|  <b style="font-size: 1.2em;">HYUNDAI NEW THINKING. NEW POSSIBILITIES. <b style="font-size: 1.1em;">Technical Service Bulletin | GROUP AUTOMATIC TRANSMISSION | NUMBER 14-AT-009 |
| SUBJECT AUTOMATIC TRANSAXLE 4WD ECU UPDATE AND INHIBITOR SWITCH BRACKET REPLACEMENT | | |

| Event# | Description |
|--------|---|
| Event | #321 CM 2.4/3.5 4WD P1782/C1627 DTC Logic Improvement |

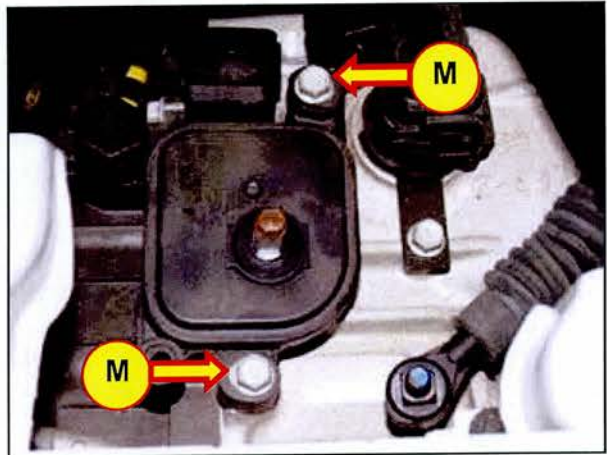
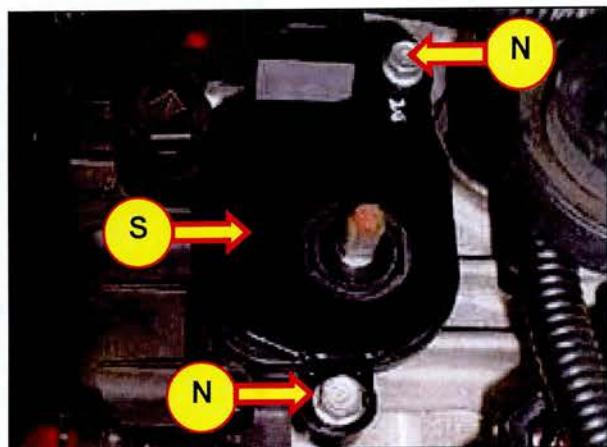
7. Remove the mounting bolts (M) and discard.

Discard the old mounting bolts (M).

8. Install the inhibitor switch bracket (S) to the inhibitor switch using the new flange bolts (N).

Tightening Torque:

7.2~8.7 lb-ft (1.0~1.2kgf.m, 9.9~11.7 N.m)
